Technical Service Bulletin No. 17

Reference no: Diffuse display glass on listed LM 26 units.

LM 26

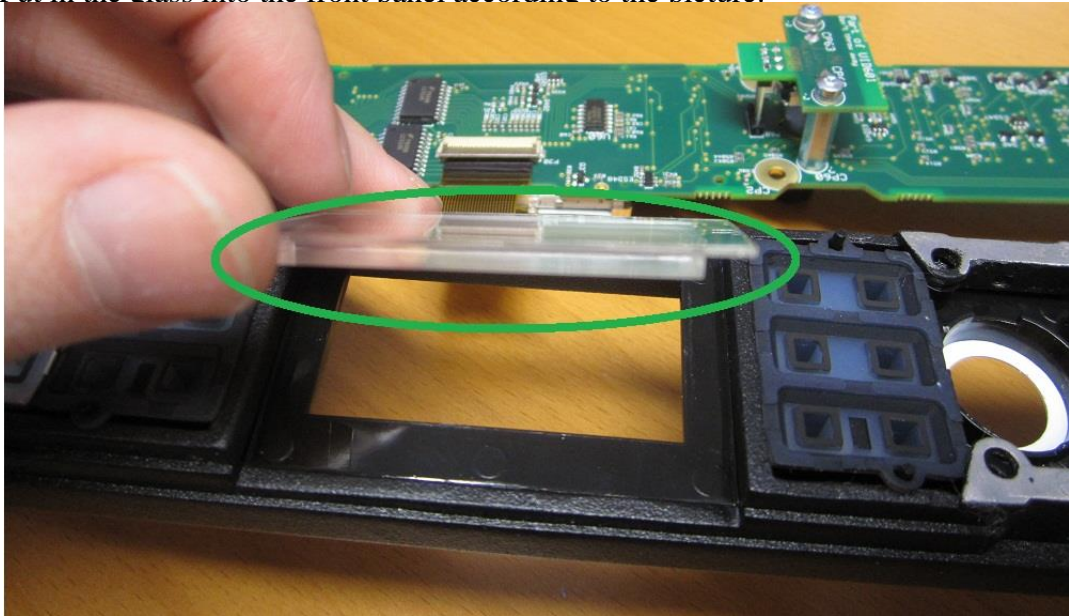
The problem is that the glasses got too much anti reflex treatment that makes them slightly too diffuse. The display appears to be slightly out of focus. There is no functional problem with the units and they do not have any other problems.

Change the display glass component to the new version of ACUID_02. This is a glass with correct anti-reflection.

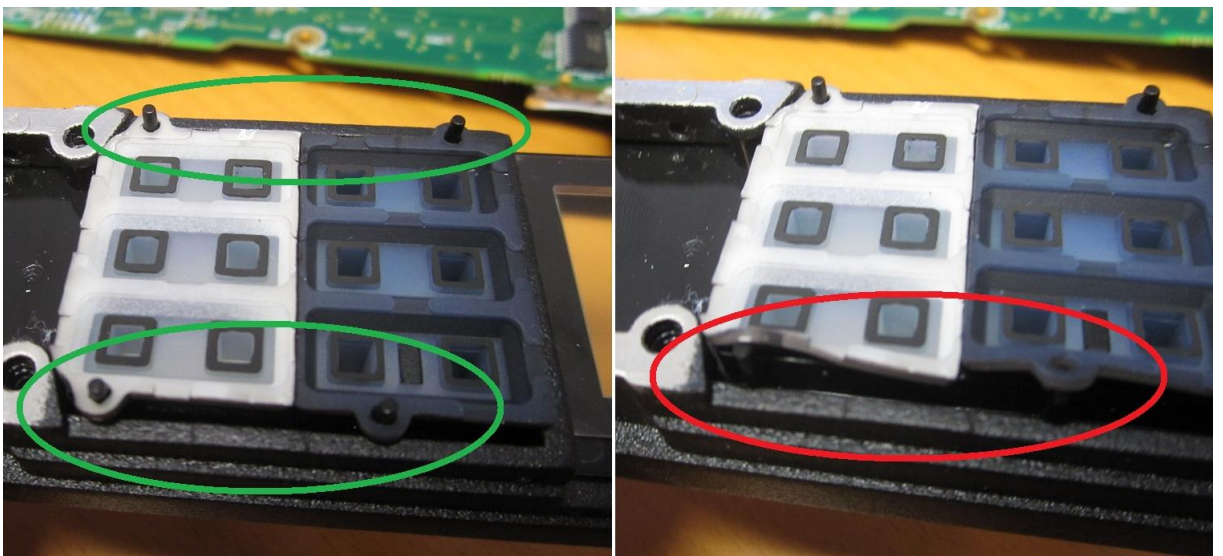
1. Put in the glass into the front panel according to the picture:

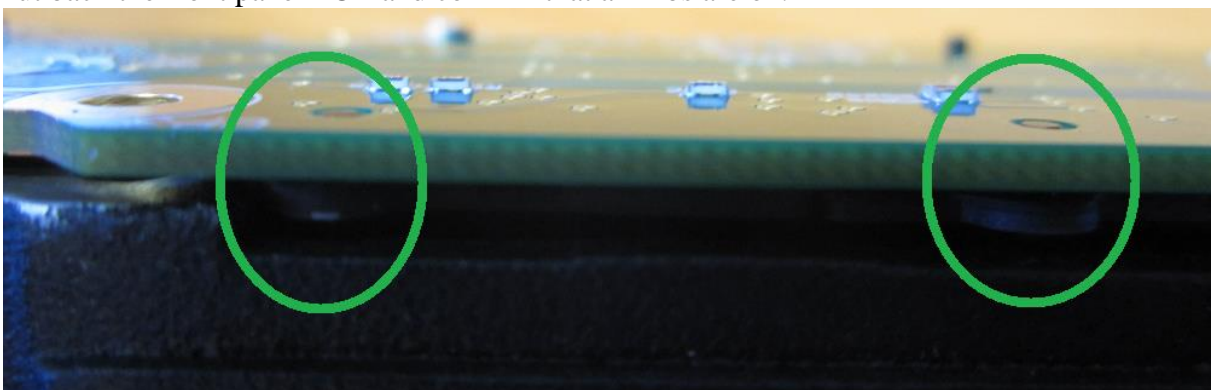
2. All nibs must pass the holes in the silicon keys on all positions.

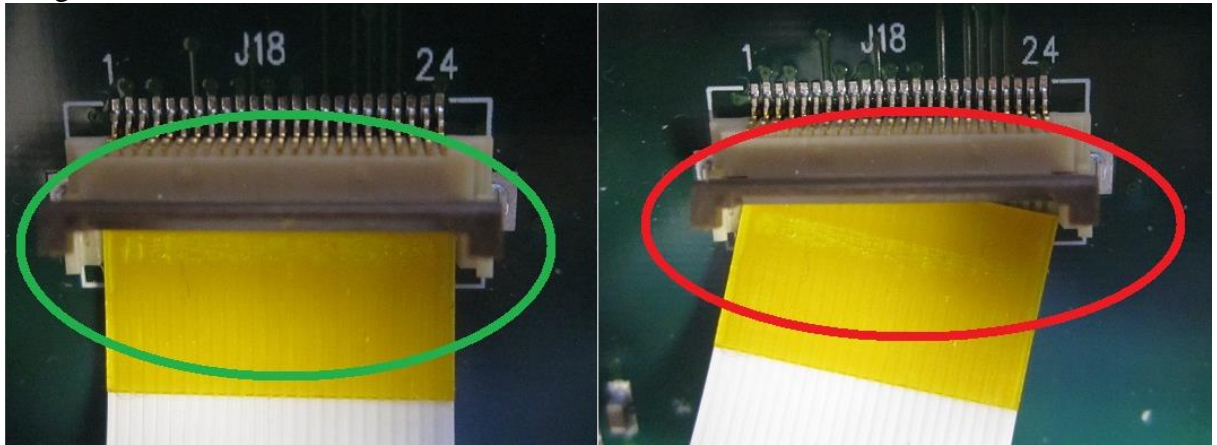
3. Put back the front panel PCB and confirm that all nibs are ok.
